<b>TITLE</b> CARTRIDGE DOOR OPENER BINDING ON FRONT LOADS			PIB NO. DK3067		
<b>PRODUCT LINE:</b>	<b>TAPE DISK FORMATTER</b> <input type="checkbox"/> TAPE <input checked="" type="checkbox"/> DISK <input type="checkbox"/> FORMATTER	<b>EQUIPMENT CHANGED</b> N/A	<b>MODEL SERIES AFFECTED</b> D3000 (Front loads)	<b>EFFECTIVE DATE</b> 2/15/77

TITLE CARTRIDGE DOOR OPENER BINDING ON FRONT LOADS

PIB NO.  
DK3067

FIGURE 1

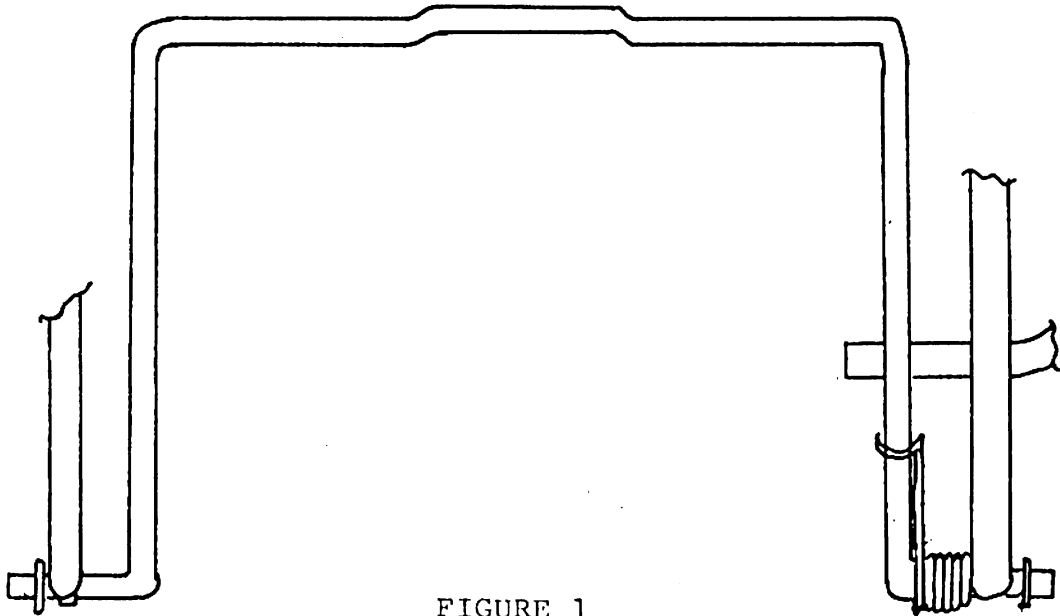
To inform customers of a dimension change to the Door Opener (P/N 102624-01) and Spring (P/N 102753-02) that would insure the return of the Cartridge Door Opener to its original position.

1. Remove old Door-Opener and hardware.
  2. Install new Door-Opener, identifiable by dimension change;  
(See figure 1 below)
  3. Install new Spring and hardware in accordance with Figure 2.
- NOTE: Extra washers and retaining clip.
